Pre-Design Investigation
(Additions)

ADDRESS 5121 GIBSON ZONE ATLAS # LIB/D36

PROPOSED DEVELOPMENT ADDITION

SITE PLAN 1"=200'

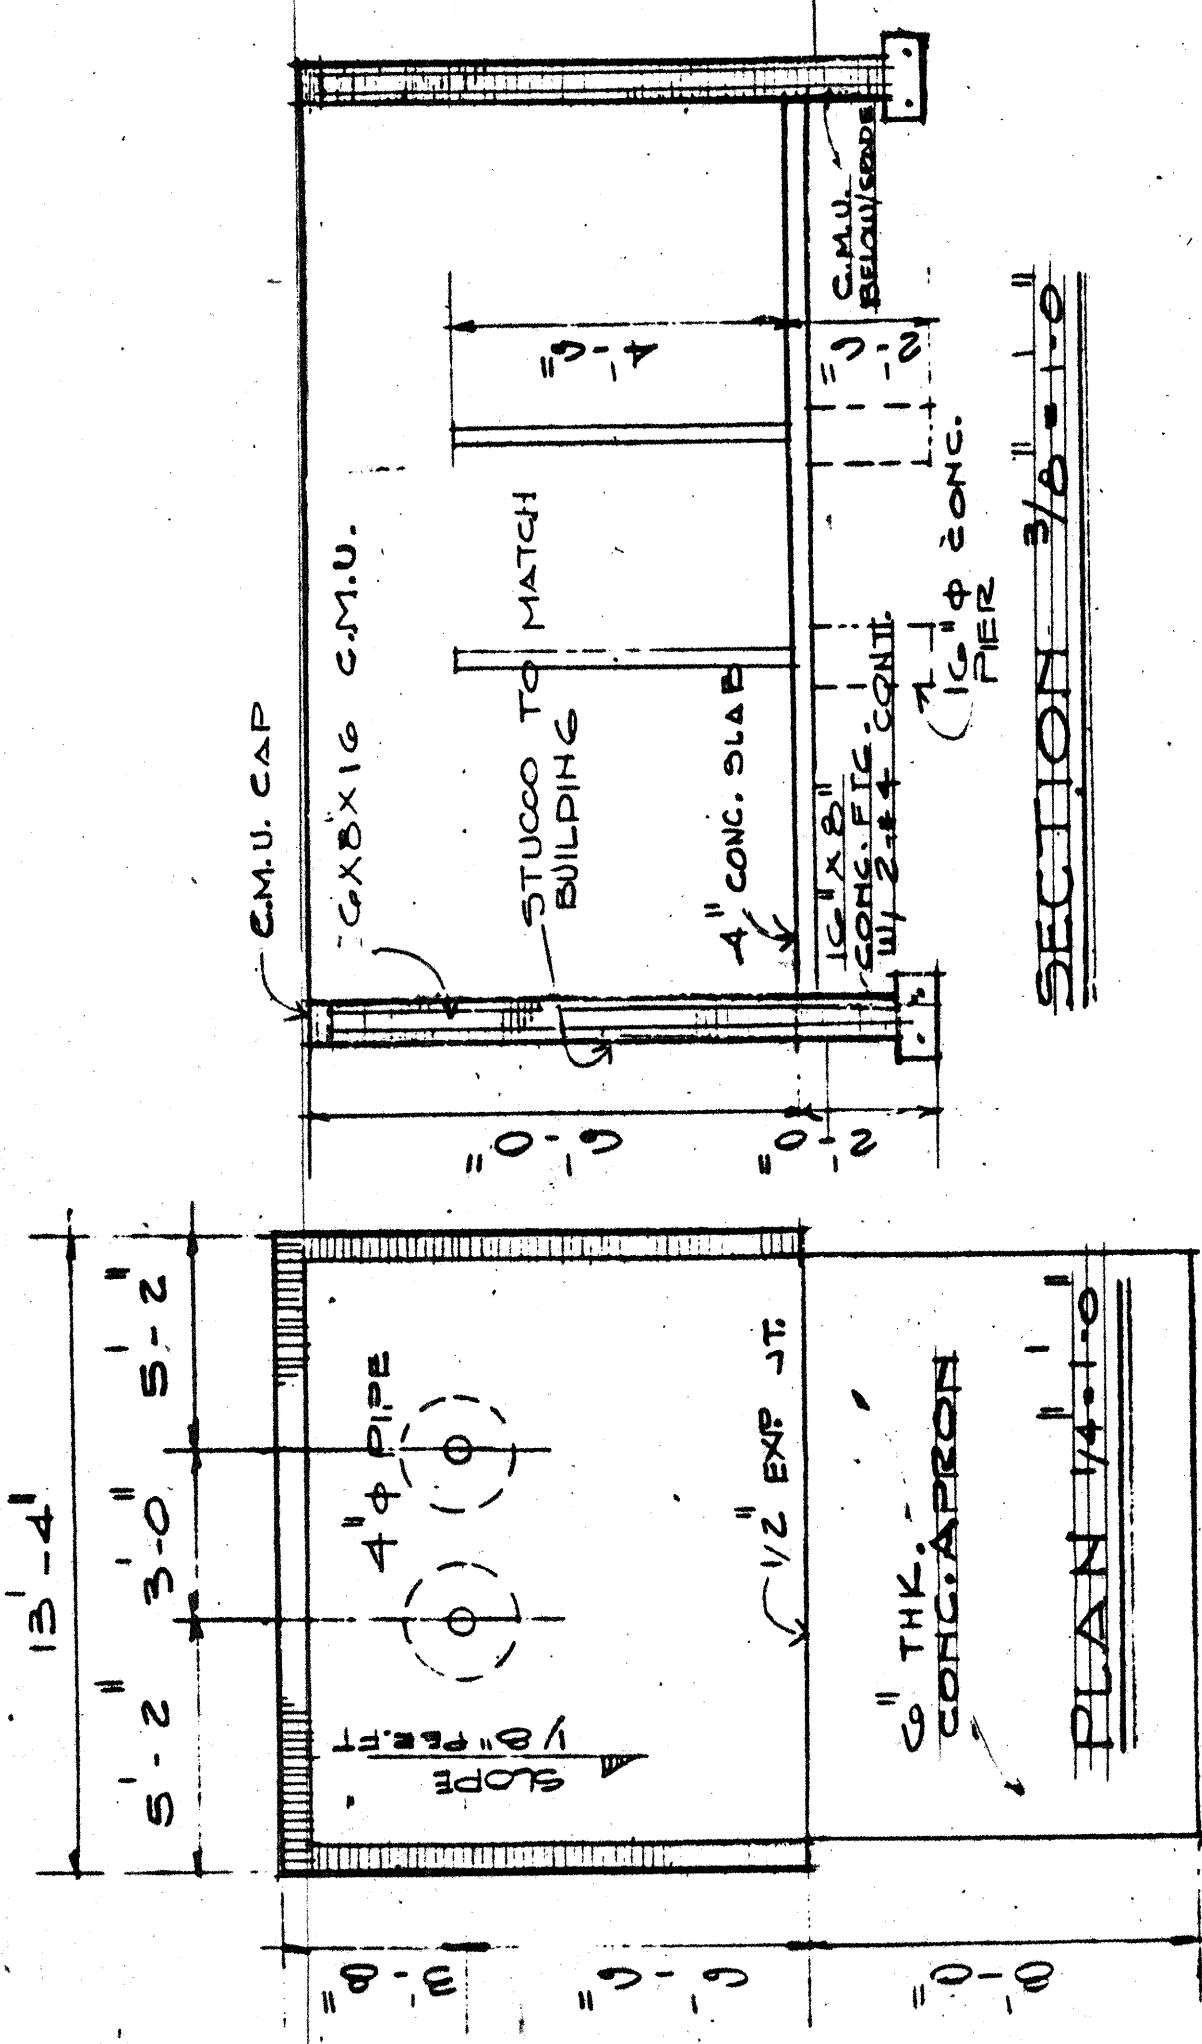
RUN-OFF ~~IS~~ CURRENTLY TRAVELS
TO THE NORTH EAST CORNER OF LOT. (INTO MADIRA)
IT APPEARS THAT SOME RUN-OFF CROSSES THE
NORTH PROPERTY LINE INTO ADJACENT PROPERTY
DRAINAGE REQUIREMENTS:

1. Finish Floor elevation to M.S.L. for Existing & proposed Building.
2. New developed run-off must exit thru a driveway onto the
street.
